DESIGN DATA REPORT for the CACTUS ROAD STORM DRAIN (67th Avenue to the Agua Fria Freeway)

**FLOOD CONTROL DISTRICT
of
Maricopa County**

Appendix F includes all the comments and responses for the 65 percent and the 95 percent submittals.

SHEET	C-1
PROJECT NO.	
DWG. NO.

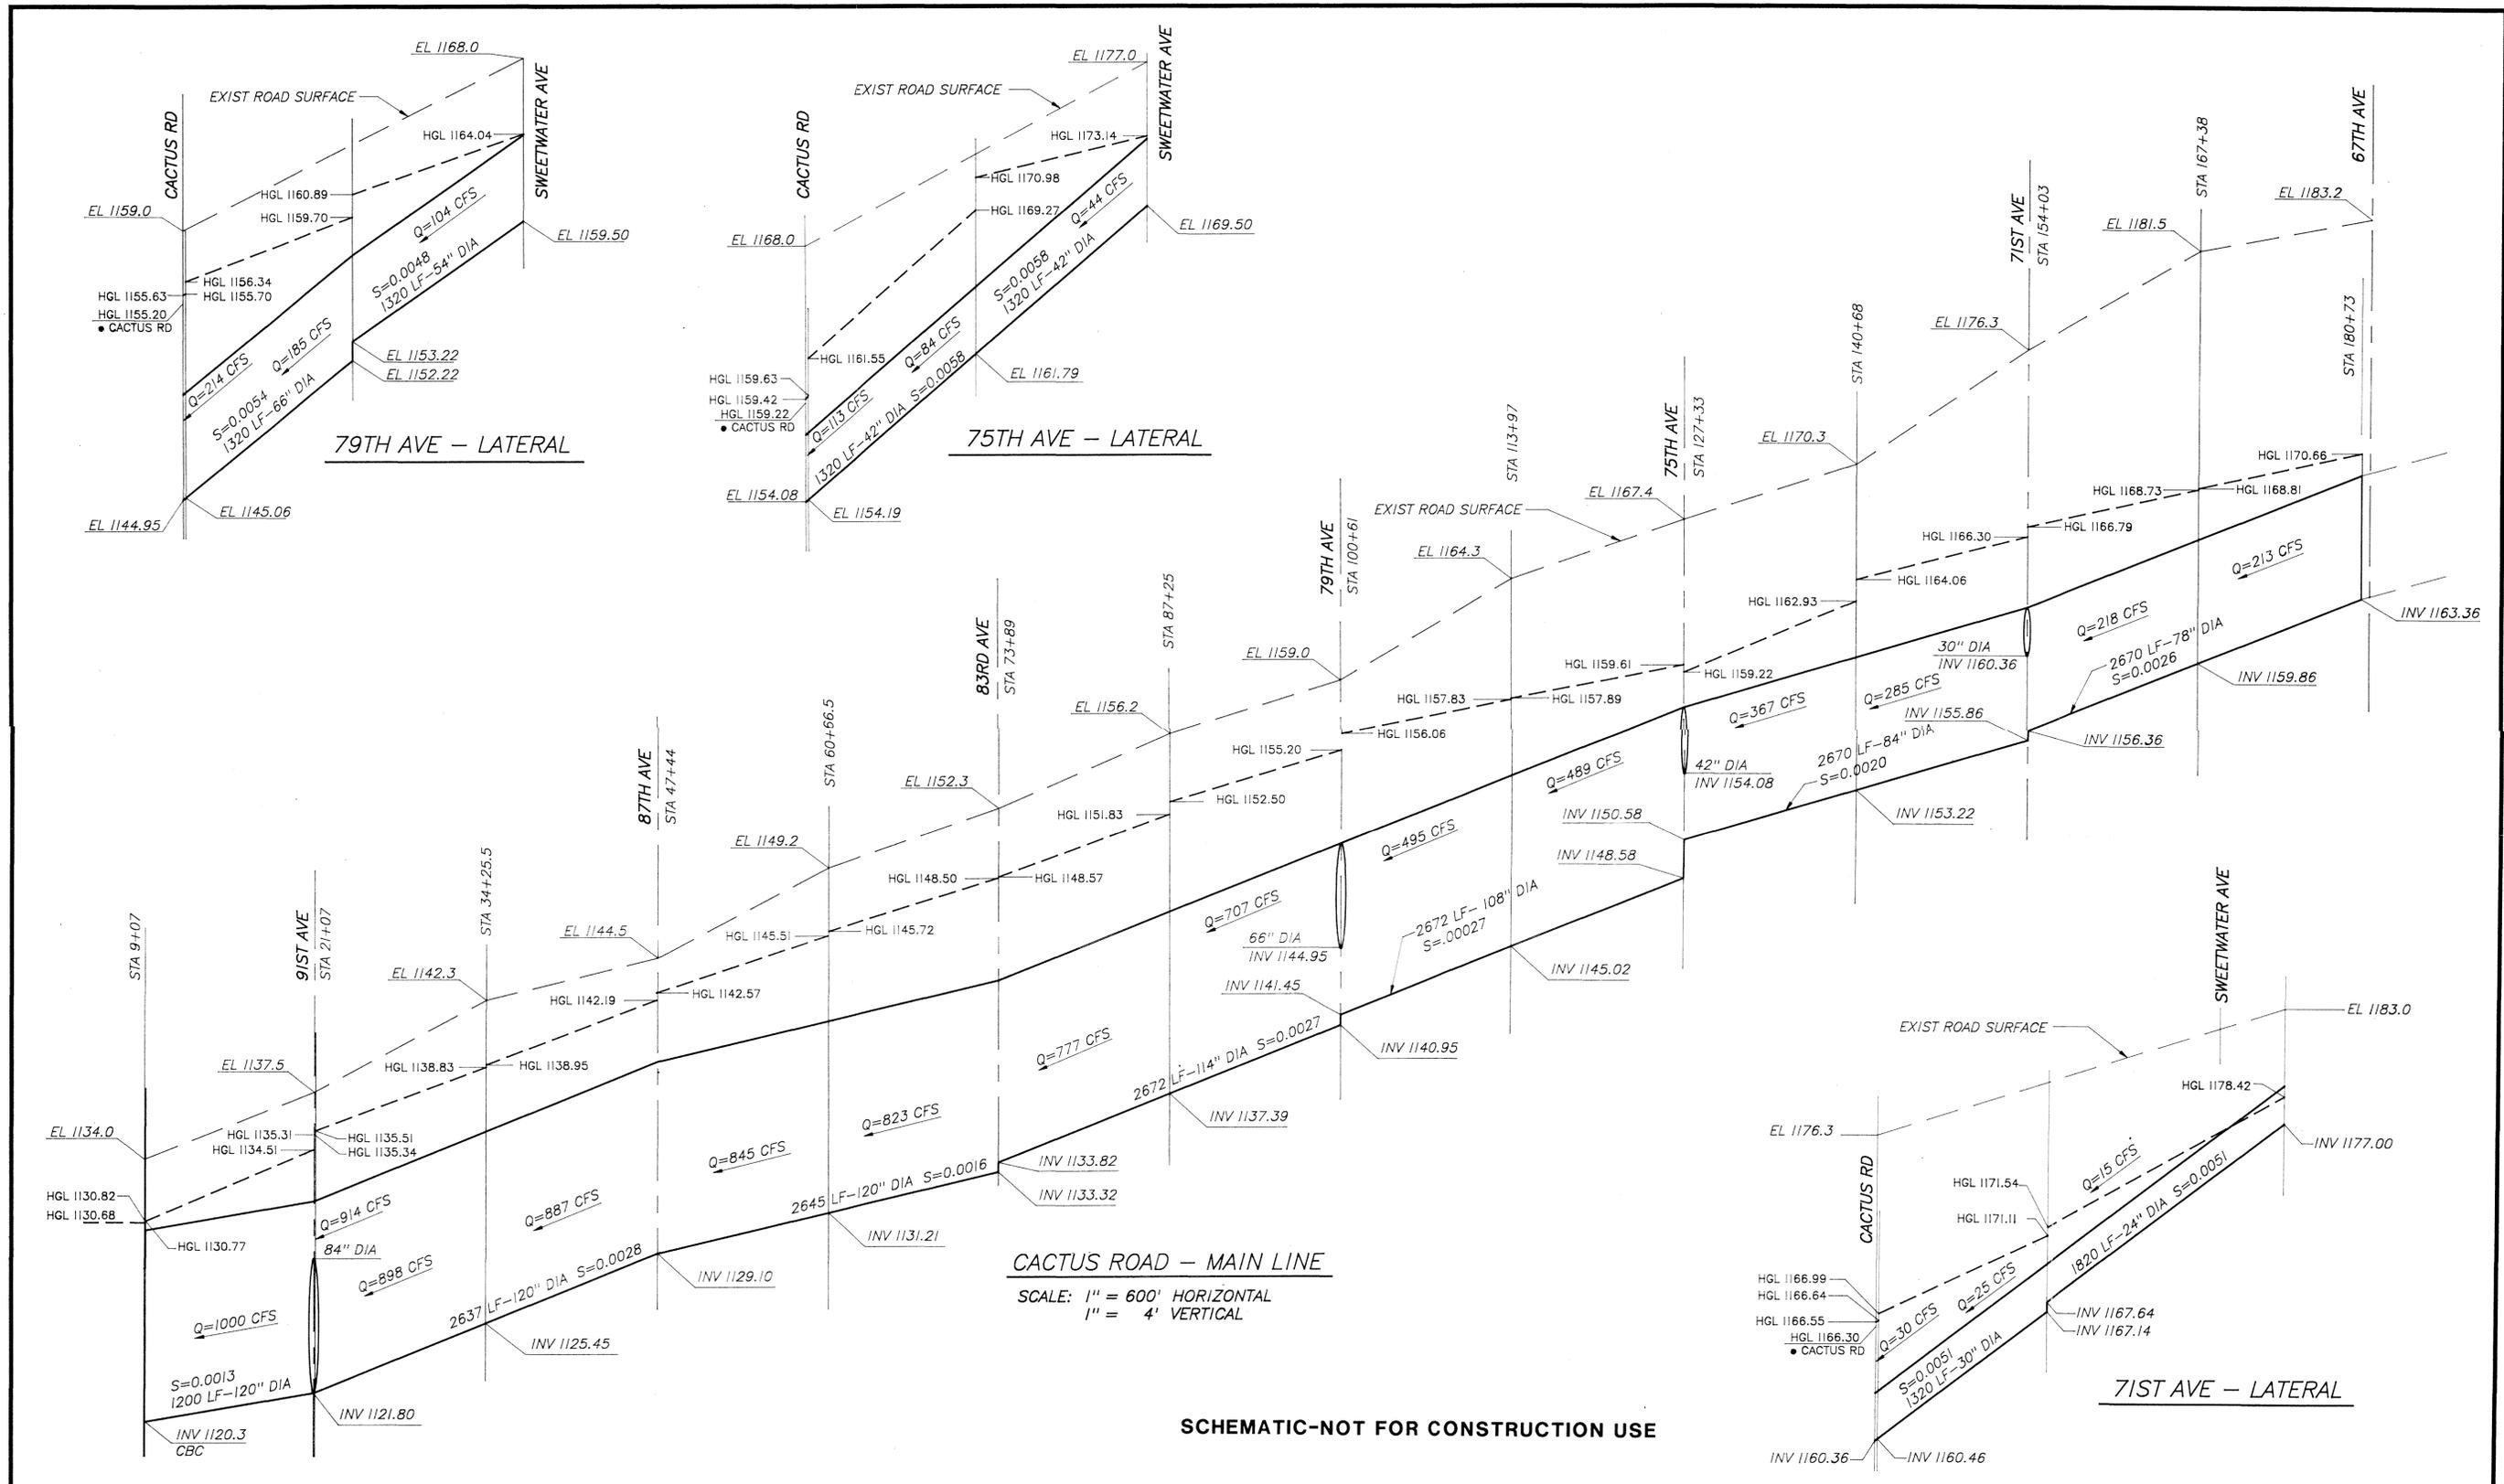
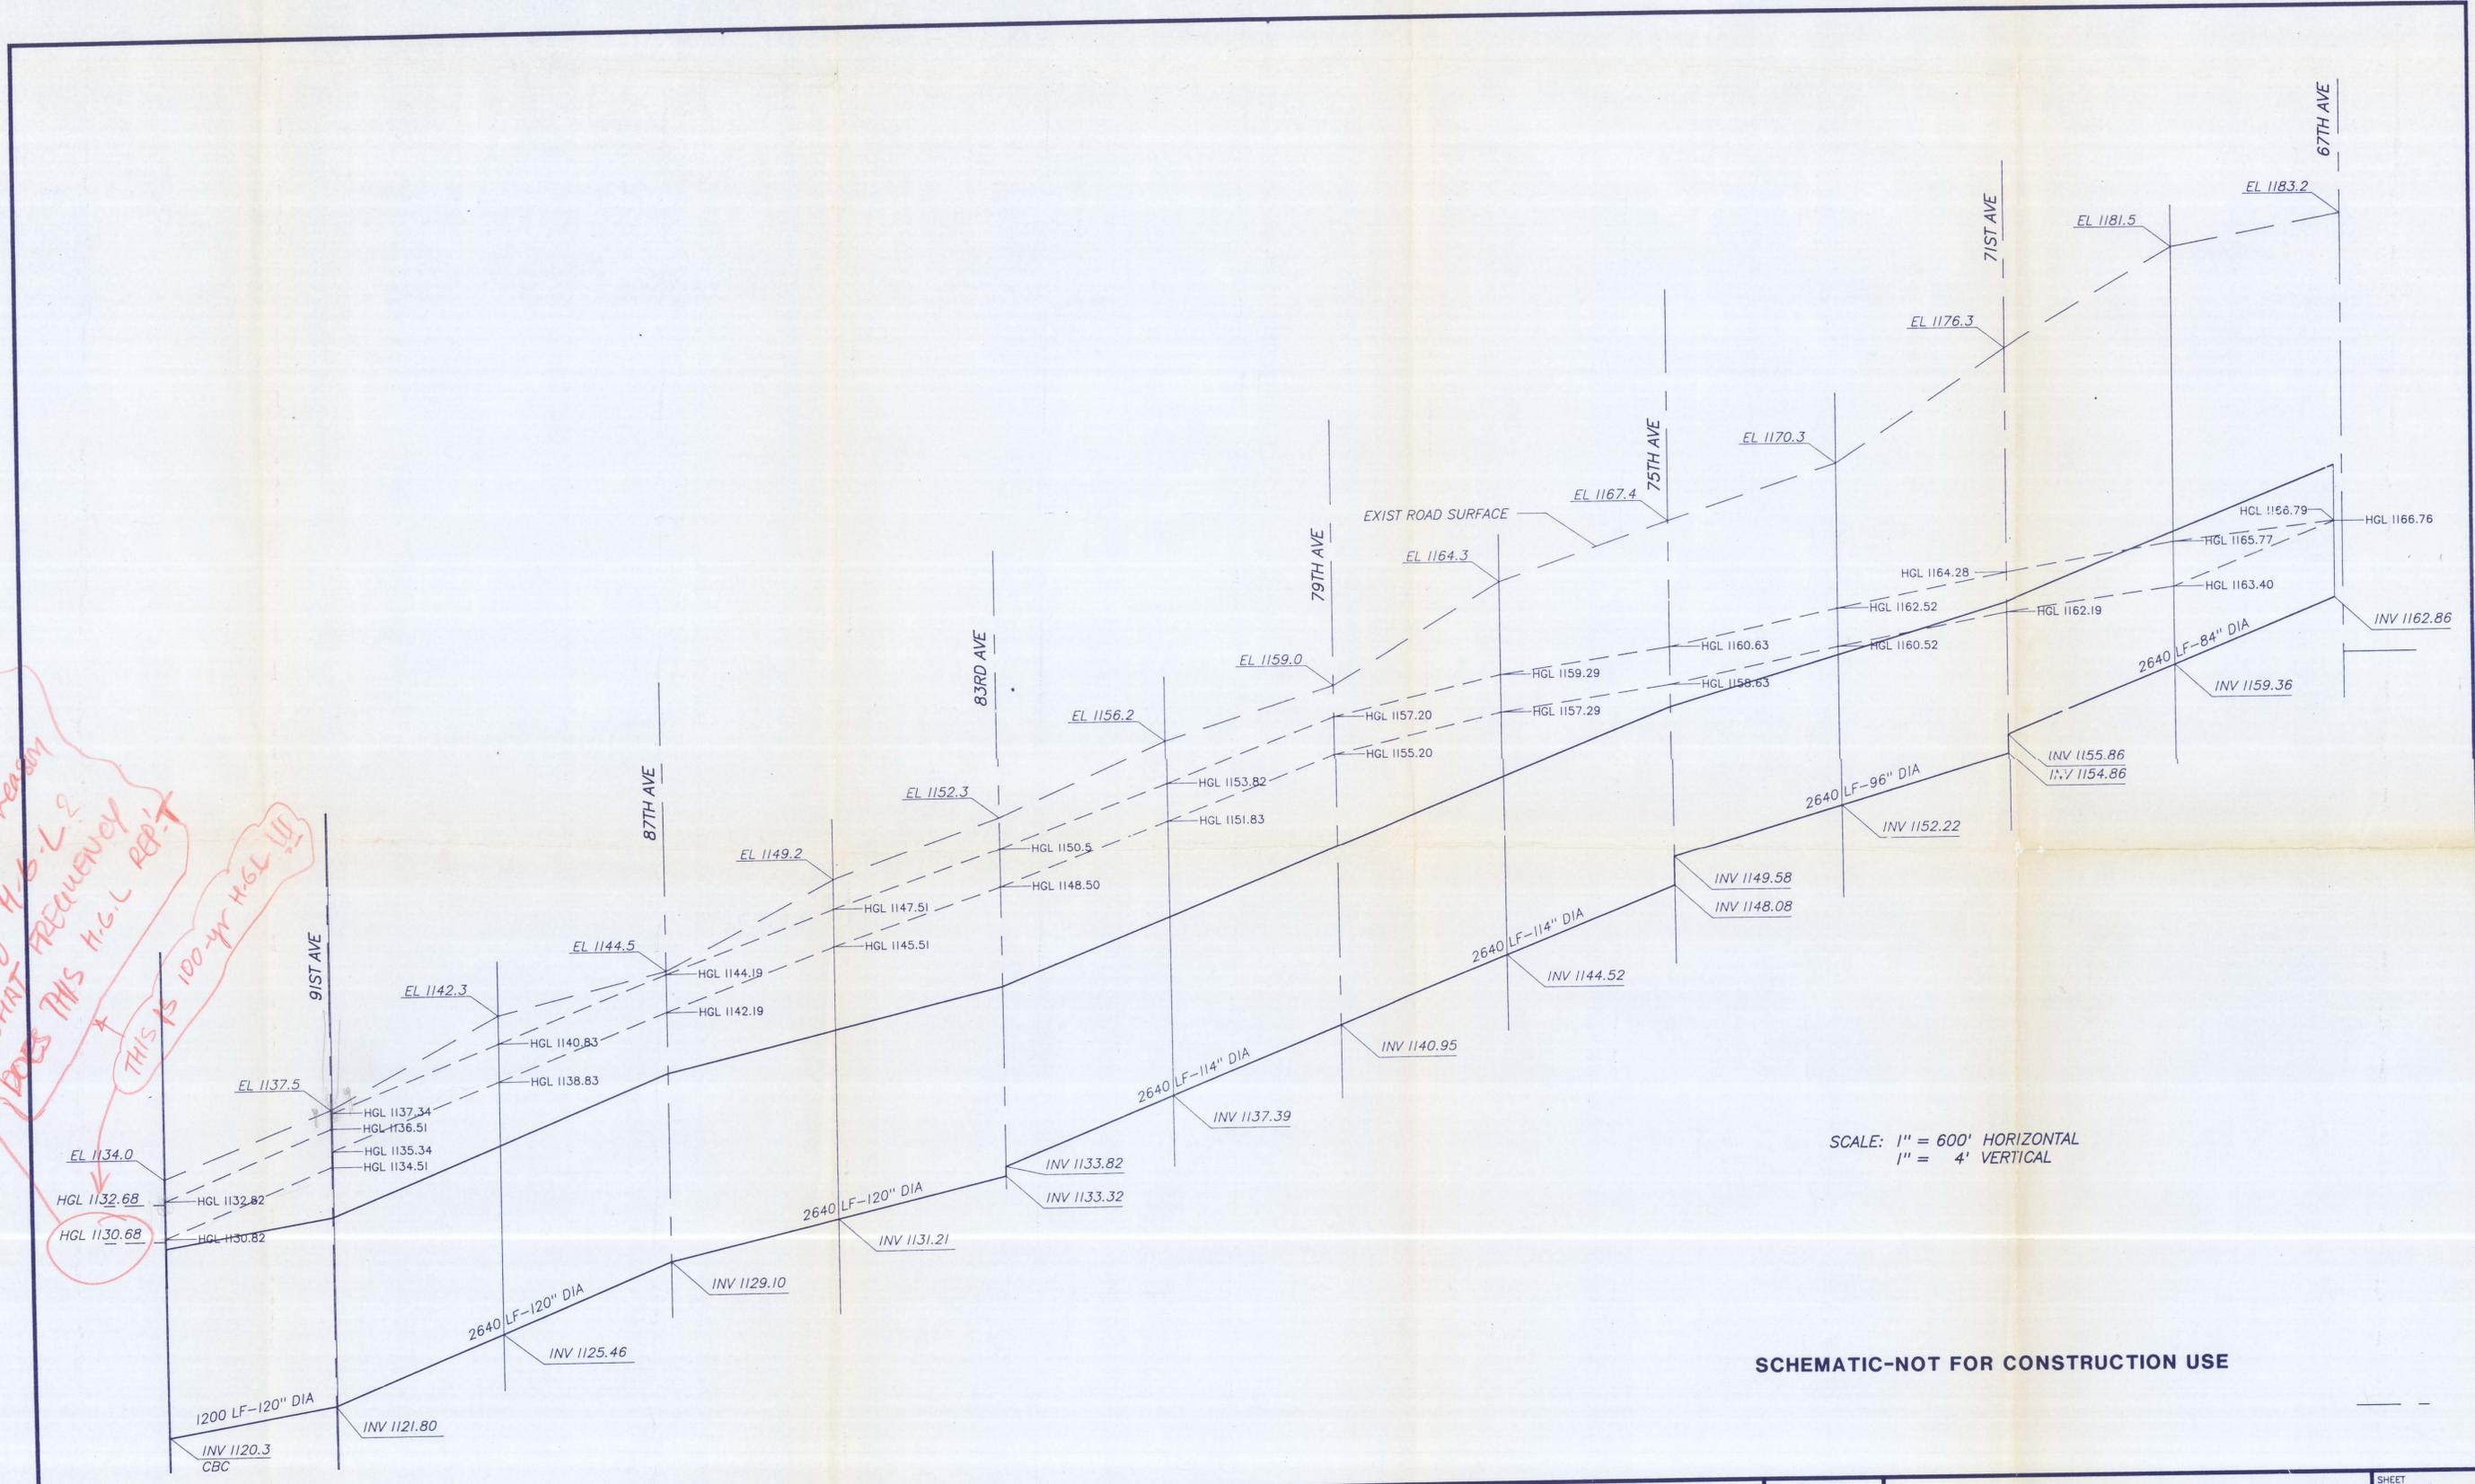
What is the reason for lowering H.G.L. or what frequency does this H.G.L. represent? THIS IS 100-yr H.G.L. !!!

RESPONSE: The hydraulic gradeline was generated using the HEC model flow rates and stations. On sheet C-1 in the design data calculations you will find that the quantity of flow changes at station 60+66. This is the station used on the plan and profile sheets although the catch basins are located slightly upstream and are the actual physical locations for the change in flow. The HGL shown on these plans is an approximation of a particular flow condition and is the best approximation of the highest flow conditions anticipated under the design assumptions of the HEC model. Normally the HGL would not be shown because it would be given in the Drainage Master Plan and based on a routing model for approximate inflow locations. In this case, the HGL was calculated by the Engineer and not provided by the client. If showing the HGL and EGL in this manner is confusing, it could be removed and the reviewing agencies could use sheet C-1 to check hydraulic calculations. There is no reason to include it on the construction plans for the contractor.
